Cessna Throttle Control Attachment Replacement

SE79-6

SUBJECT: ENGINE CONTROL ATTACHMENT

2 86-24-07

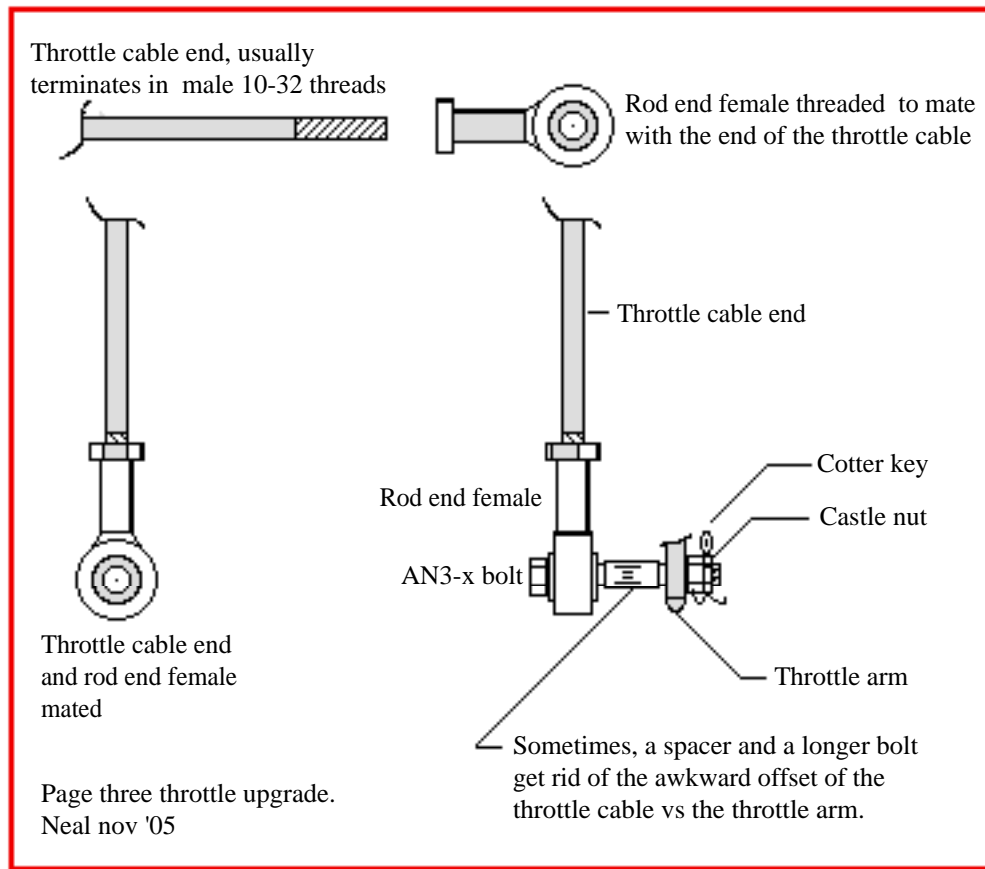
(a) Modify the engine controls installation by installing a drilled steel bolt, AN310 type castellated nut and a steel cotter pin in accordance with Cessna Single-Engine Customer Care Service Information Letter SE79-6. *copy attached.*

The throttle, mixture, and propeller control cable ends are now being secured to the engine with a predrilled AN bolt, castellated nut, and a cotter pin.

Replacement of any undrilled bolts and self-locking nuts with an AN bolt of appropriate size and length, predrilled for use with an AN 310 castellated nut and cotter pin is recommended. This improved type attachment should be incorporated on all earlier aircraft at the next 100 hour or annual inspection.
